# Greater Geelong Planning Scheme Amendment 278ggee Marshall Precinct Structure Plan

Expert Witness Report

Prepared for:  
Re-Grow Geelong Pty Ltd c/o Maddocks

28 October 2024

Figure 4.1: Estimated Daily Volumes from Marshal PSP (Figure 7-1 of 2019 Cardno Report)

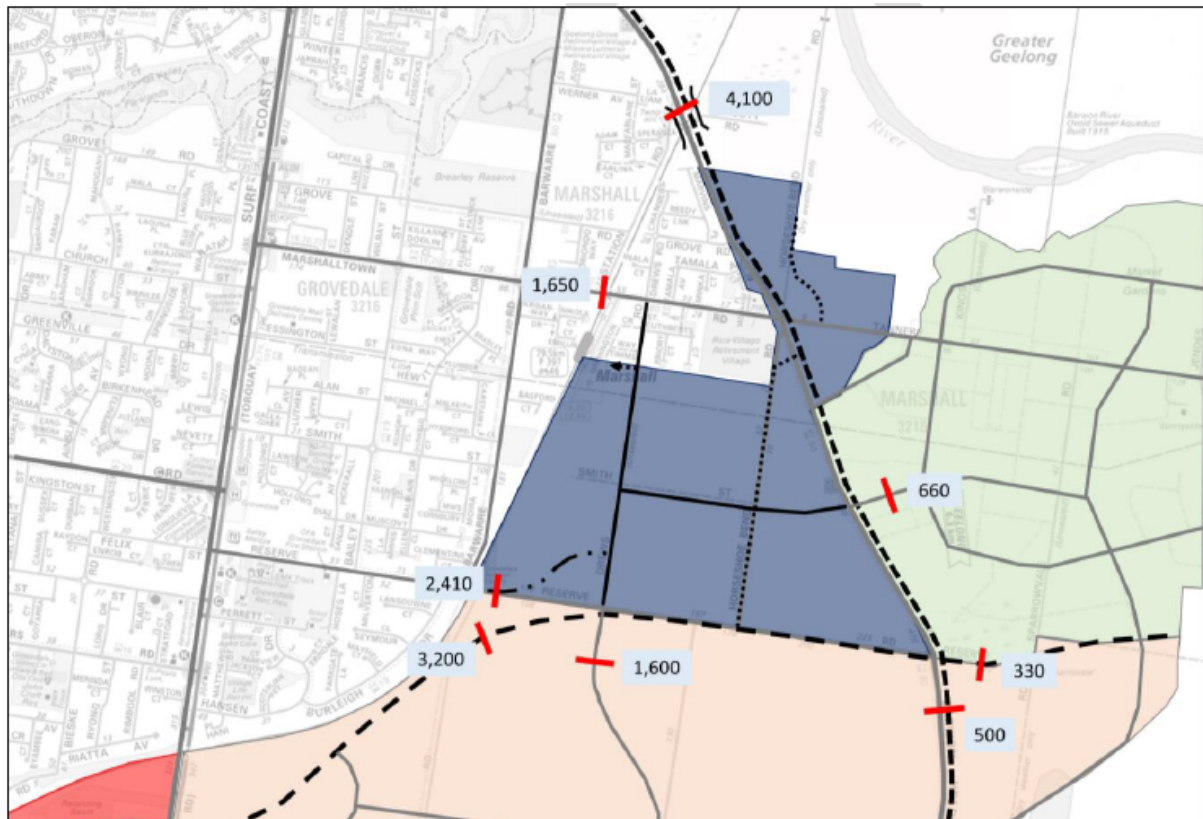
The peak period volumes are very inconsistent with the daily volumes articulated in Figure 7-1 of the Cardno report. It is also unclear as to why the volumes reduce in 2046 from the NEIP, but it can only be assumed that this is based on the 2046 volumes ascertained from the Jacobs analysis.

Figure 4.2: 2046 AM (left) and PM (right) 'Ultimate' volumes at IT-02 as per the 2019 Cardno Report

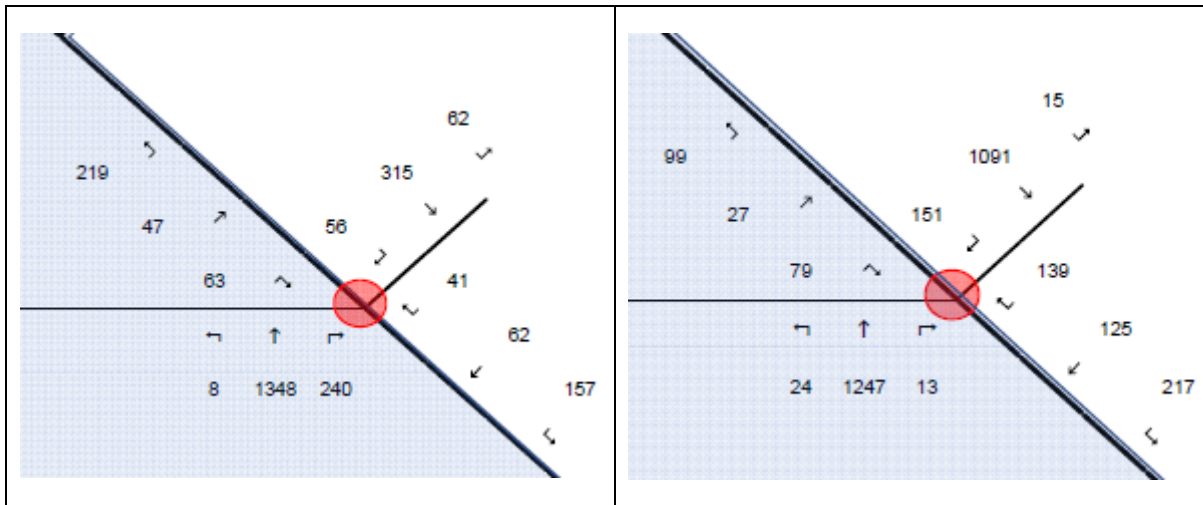
A further review of the report indicated that the analysis for IT-02 was based on the 2046 'Ultimate' volumes in the Cardno report. I have reviewed the SIDRA analysis presented in the Ratio report and can confirm that the volumes used in the analysis are the same as those presented in Figure 4.2 of this report.

Figure 5.1: Intersection IT-02 (Barwon Heads Road / Keystone Avenue) as shown in the DCP

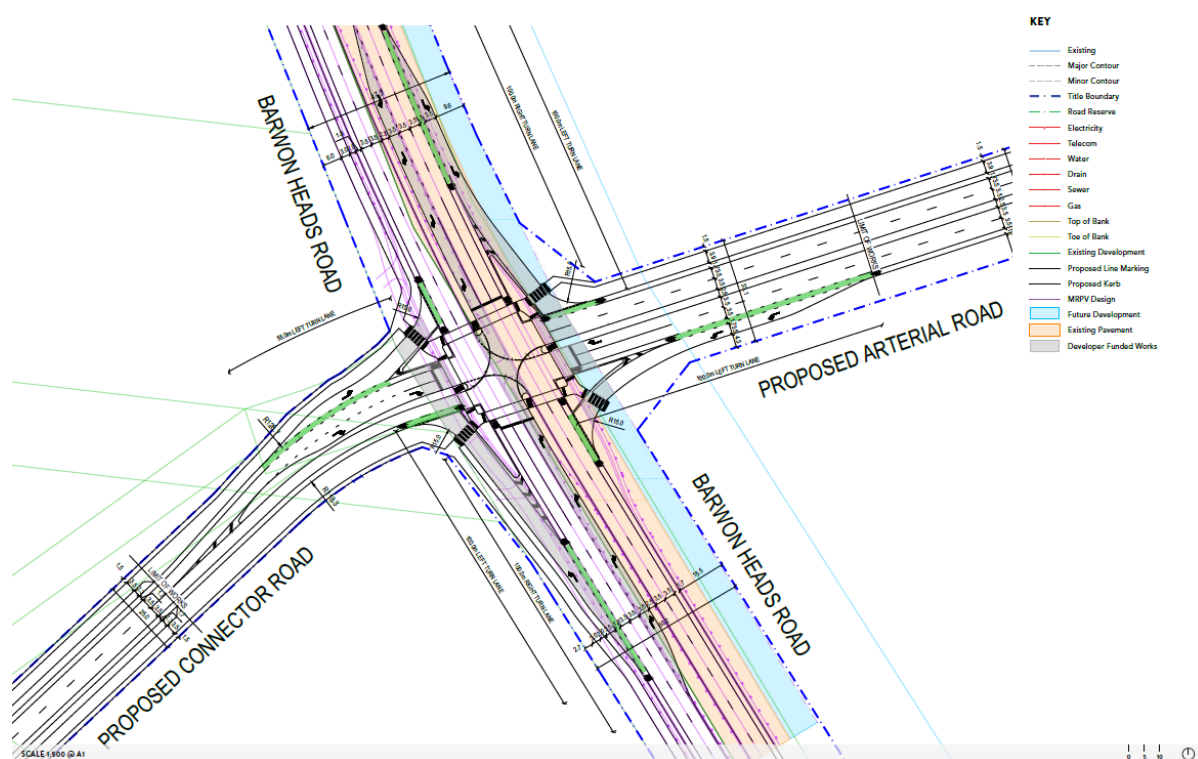
It is understood that this plan was prepared prior to the completion of the Barwon Heads Road upgrade and is based on an old concept of the road.

The results show that the volumes anticipated for IT-02 as part of the first principles analysis would result in the performance of the intersection proposed within the Marshall PSP to be significantly compromised. Indeed, degrees of saturation of greater than 1.5 would be experienced on Barwon Heads Road and on Keystone Avenue within the NEIP that would result in queueing and congestion of greater than 1.8km that would result in significant impact on the broader transport network.

Figure 5.3: Proposed SIDRA Intersection layout

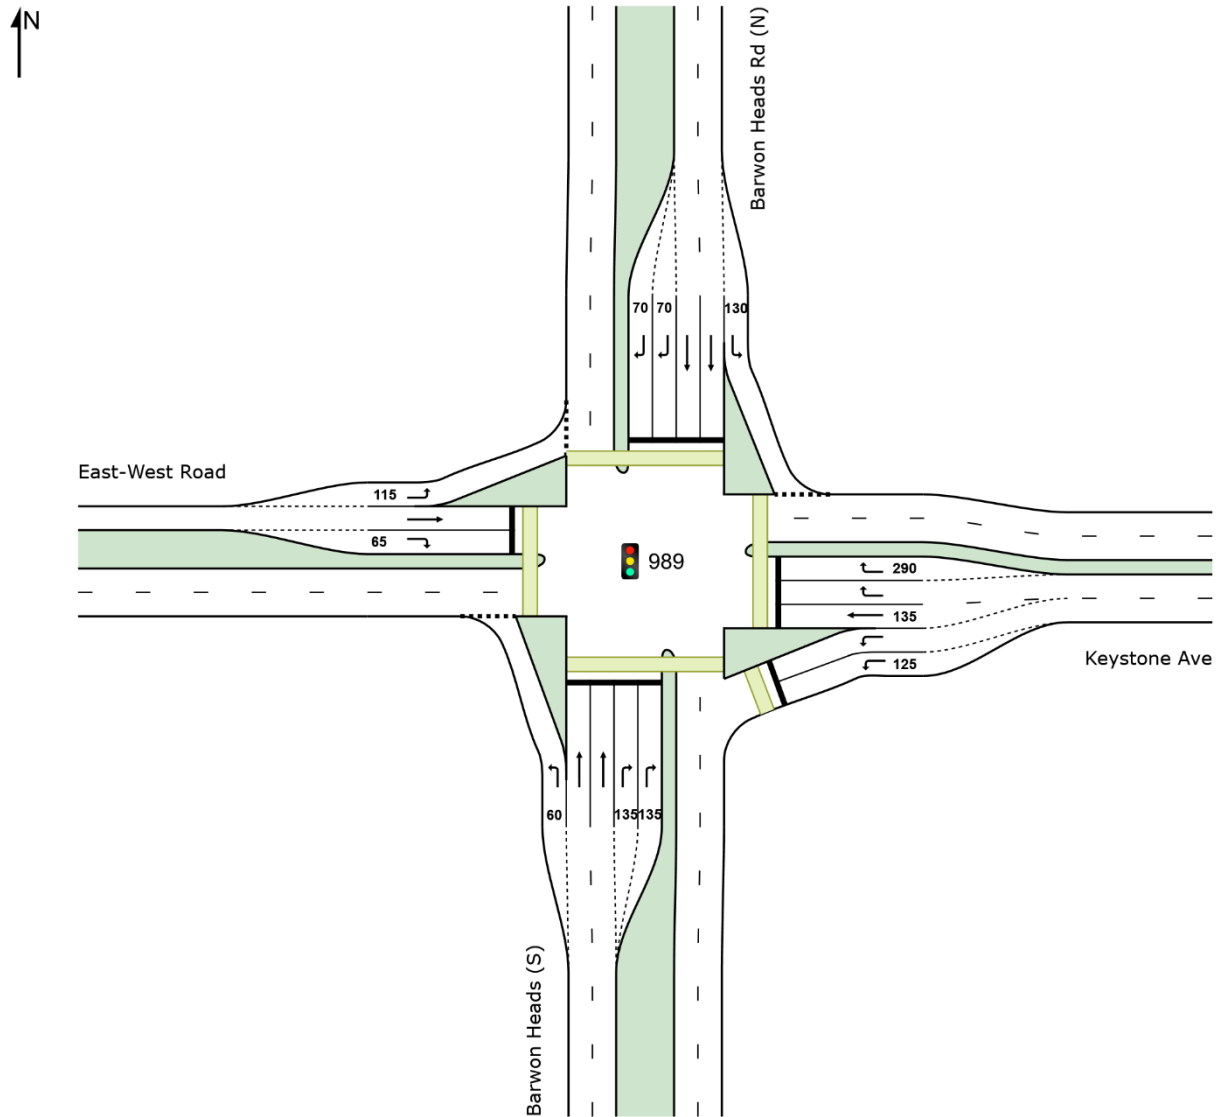
The proposed intersection layout was determined through an iterative approach to accommodate the demands using the same principles as the Ratio TIAR which is for a 120 second cycle, a target degree of saturation (DOS) of 0.95 and a level of service (LOS) D.

The results show that the volumes anticipated for IT-02 as part of the first principles analysis would be too large and that the performance of the intersection would be compromised. Indeed, degrees of saturation of greater than 1.0 would be experienced on Barwon Heads Road and on Keystone Avenue within the NEIP that would result in queueing and congestion that would impact on adjacent intersections both within the NEIP and on the broader network.

Figure 6.4: Swept Path for a 12.5m Rigid Vehicle

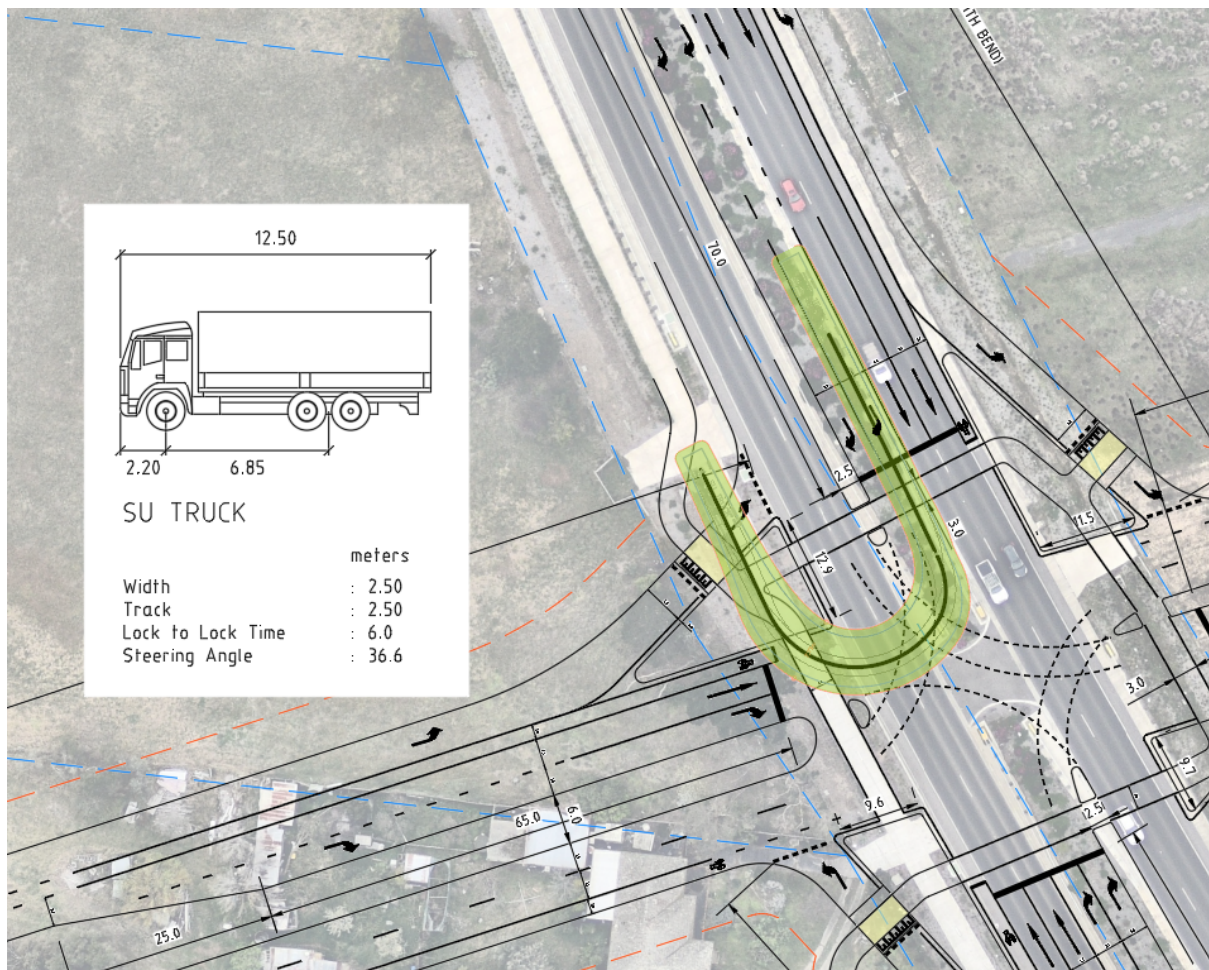
Due to the geometric configuration of Barwon Heads Road and Tannery Crescent, vehicles will not be able to perform a U-turn movement from the north. As such a redesign of the intersection will be required or alternatively, vehicles will be required to travel a further distance through the network to reach their destination.

The Marshall TIA prepared by Ratio does not include an assessment of the Marshelltown Road / Barwon Heads Road / Tannery Road intersection. It is not clear if the intersection has the capacity to accommodate the additional traffic generated from the Commercial / Bulky Goods uses. Given the change in land use and the level of traffic anticipated, it would be prudent to undertake an analysis of the intersection to understand the implications of the specific land use contemplated.

Given the above, it is recommended that the Marshall TIA be updated to include the analysis of the Barwon Heads Road / Tannery Road intersection so that it can identify any works required to facilitate the proposed Commercial / Bulky Goods uses. Further, it is requested the Greater Geelong City Council provide detail on how the bus only link will operate through the intersection with the additional Commercial / Bulky Goods traffic.
